RTS-TB-015**11-January-2013****RVON-2 Mechanical Interference in DKP16 CLD assembly can create Unreliable Operation & DKP16 CLD 'Lock-Up'**

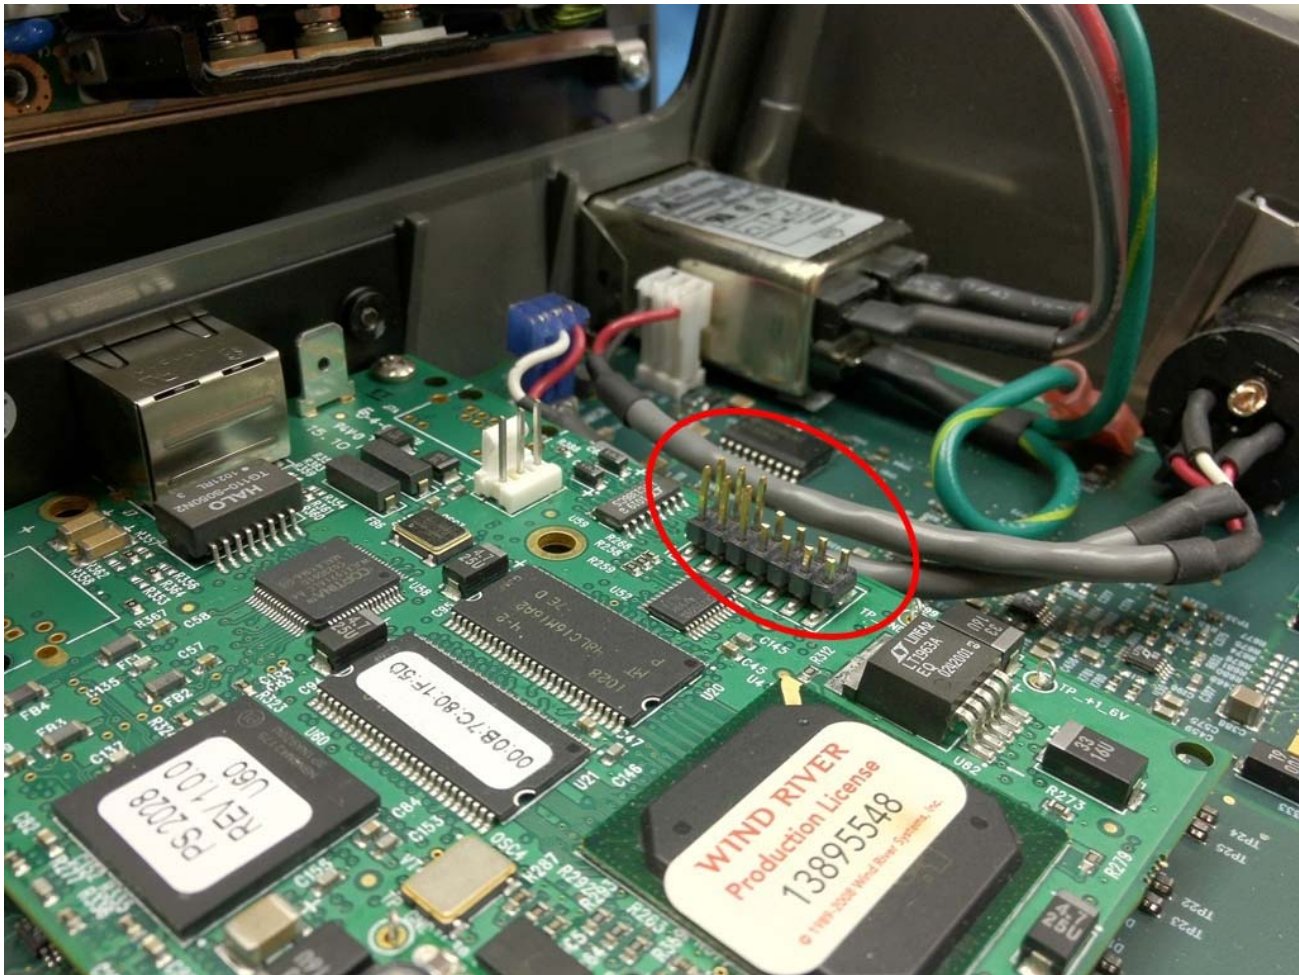
4. The RVON-2 card should be clearly visible within the unit along with programming header J1 (highlighted in the following photo).

5. **NOTE:** The RVON-2 header pins can be trimmed with the card seated in the unit or by removing the RVON-2 card. In either case, the repair person must be careful that the trimmed metallic waste is disposed of and not allowed to fall loose on the card or inside the unit where it could create an electronic short when the unit is re-powered.

J1 is a 14-pin programming header. It is not necessary to trim all 14 of the header pins. It is recommended that **at minimum** the 8 pins shown in the photo below be trimmed. Note that no functionality is impacted if additional pins beyond the 8 shown are trimmed.

The pins should be cut so that a minimum of 3.5 mm is trimmed. The header is not used in normal operation so it is not necessary to leave any pin length on the header for the pins that are trimmed.
